LAND USE APPLICATION - COMPLETENESS REVIEW

Subject Property:	5660 Commercial Street SE
Reference Number:	24-115890
Application Type:	Class 2 Site Plan Review
Date Application Accepted:	July 26, 2024
Applicant:	Marcus Lima marcusl@gbdarchitects.com
Contact:	Same as applicant

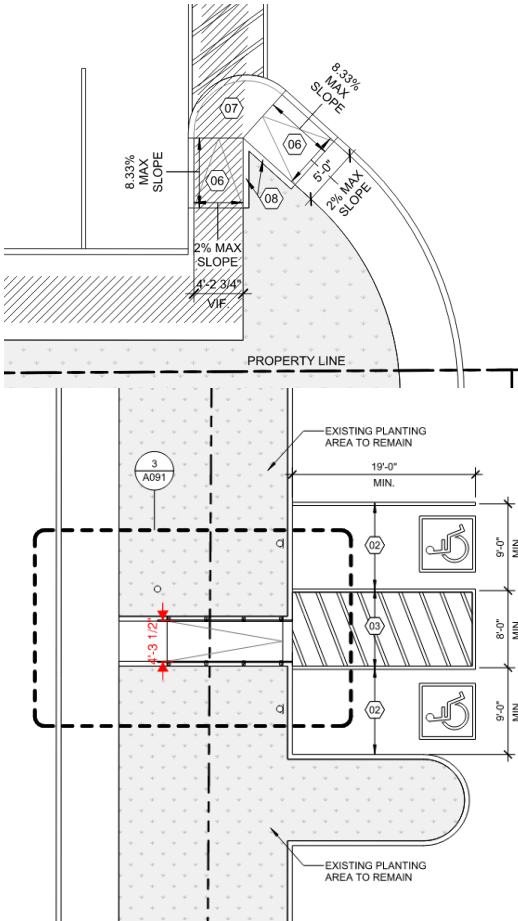
800.065(b)(1)(A) Width of Pedestrian Paths	<p>All areas altered need to meet required five-foot width for pedestrian connections. The areas shown below does not meet the five-foot width.</p>  <p>Please alter these to show the required 5 foot width.</p>
